Earthtec Engineering, Inc.

**Subject: Addendum II to Geotechnical Study
Lot 13-A-R Cedar Cove Subdivision
2716 East Bybee Drive
Weber County, Utah
EEI Job No.: 13-0055G**

Lot 13-A-R Cedar Cove Final Static

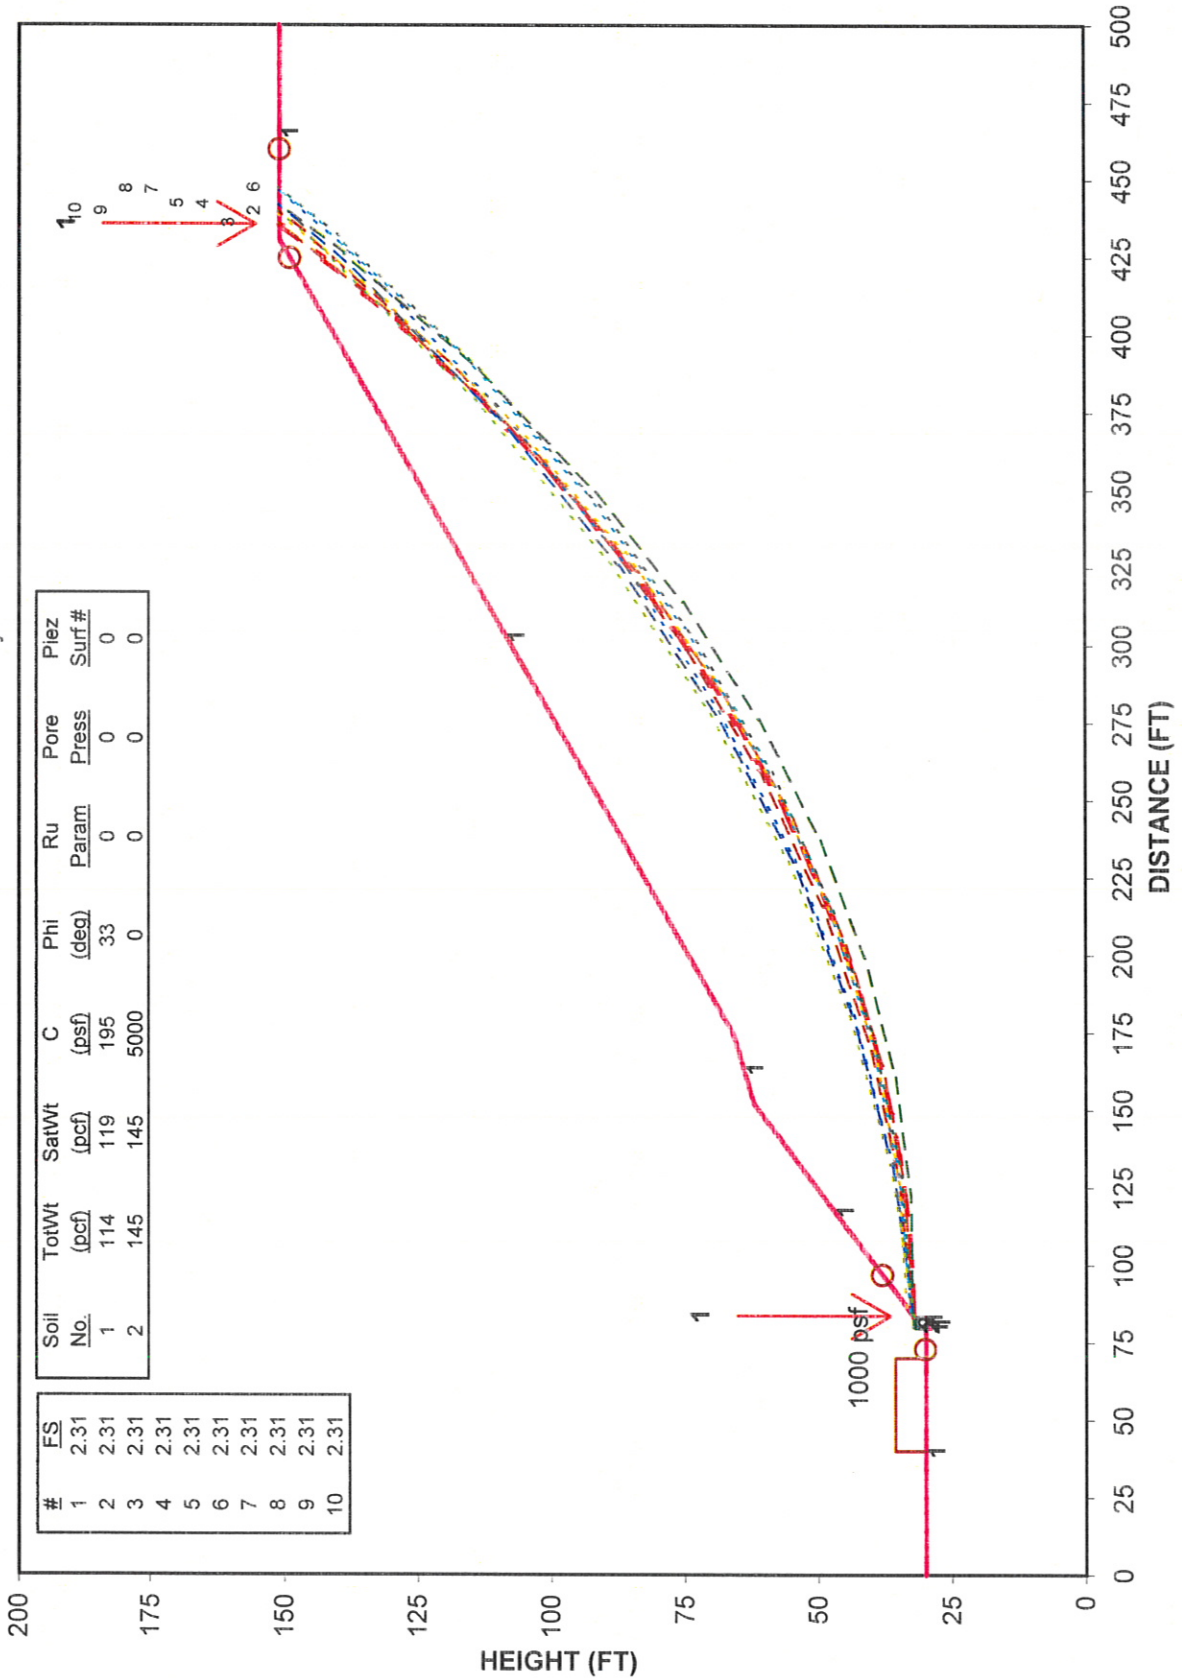
Recently, Earthtec Engineering, Inc was requested to review the site plan for the subject property prepared by Reeve and Associates, Inc., dated April 10, 2013 and prepare an updated slope stability analysis for the subject property based on the proposed site plan for the property. We evaluated the global stability of the site using the computer program XSTABLE and the input parameters indicated in the referenced report. The configuration analyzed was based on the site plan provided by Reeve and Associates and consisted of an approximately 30-foot high slope inclined at approximately 1V:2.3H (Vertical:Horizontal) followed by an approximately 4-foot high slope inclined at approximately 1V:6H followed by an approximately 80-foot high slope inclined at approximately 1V:3H. A single tier rock landscape wall composed of a single row of 3 foot diameter boulders imbedded a minimum of 12 inches below the adjacent ground surface was modeled at the toe of the slope. Typically, the required minimum factors of safety are 1.5 for static conditions and 1.0 for seismic (pseudostatic) conditions. The results of our analyses indicate that the slope configuration described above meets the required minimum factors of safety. The slope stability results are attached as Figures Nos. 1 and 2, *Stability Results*.

#	FS
1	2.31
2	2.31
3	2.31
4	2.31
5	2.31
6	2.31
7	2.31
8	2.31
9	2.31
10	2.31
